18DEVPLAN1129

Brownsboro Road Plaza

Louisville Metro Board of Zoning Adjustment

Dante St. Germain, Planner II

REVISION DETAILED DISTRICT DEVELOPMENT PLAN
HOGAN - BROWNSBORO ROAD PLAZA

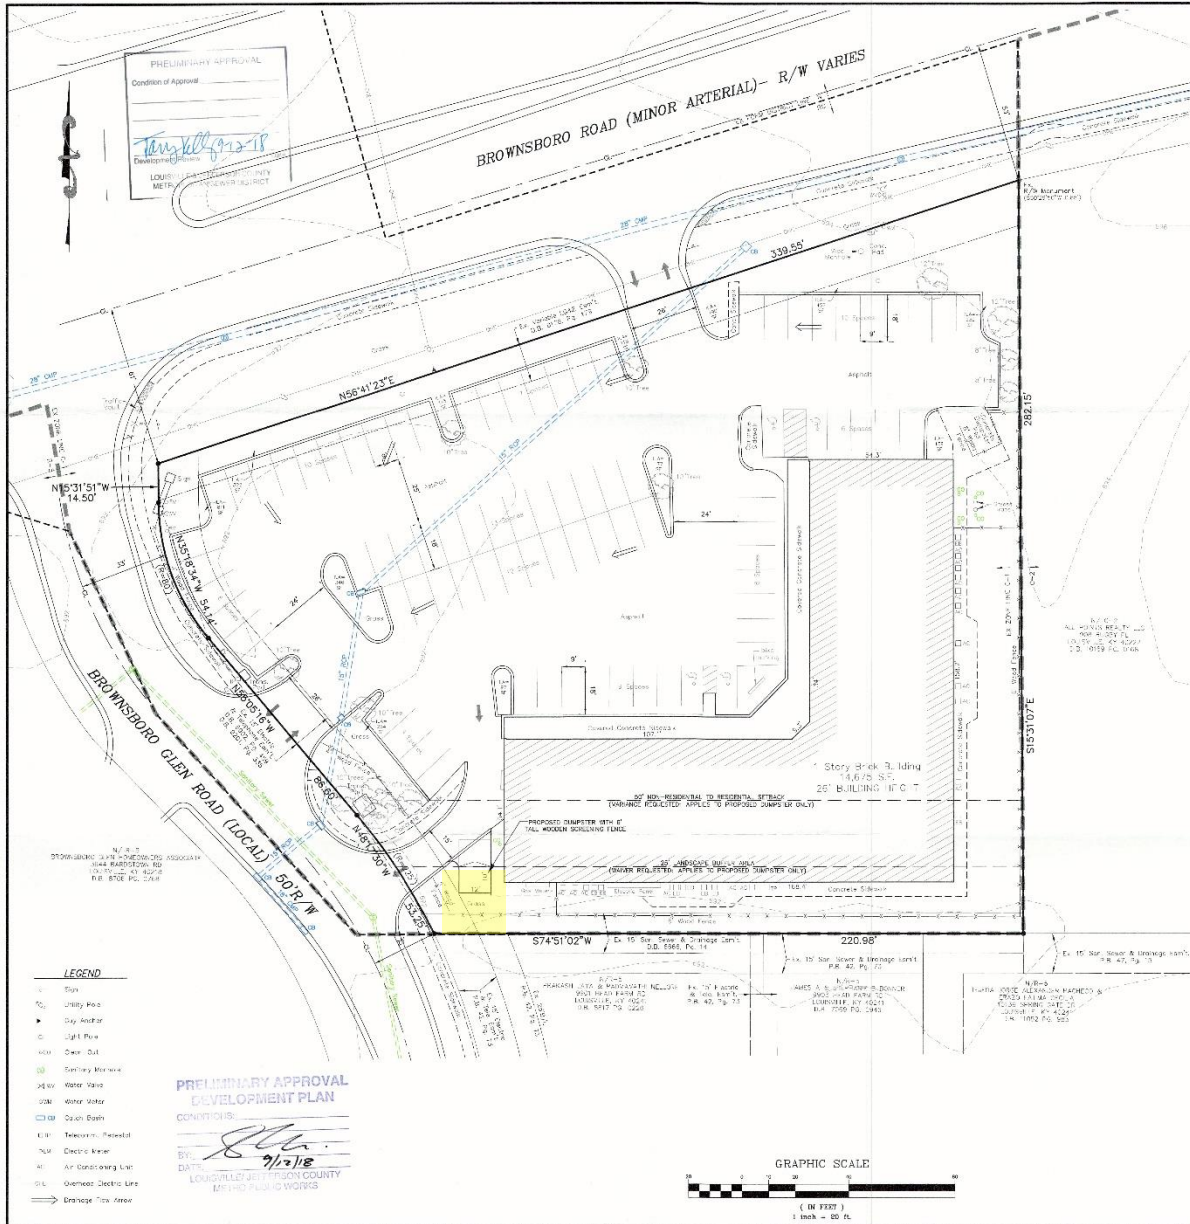
Staff Finding

- The variance request appears to be adequately justified and meets the standard of review.
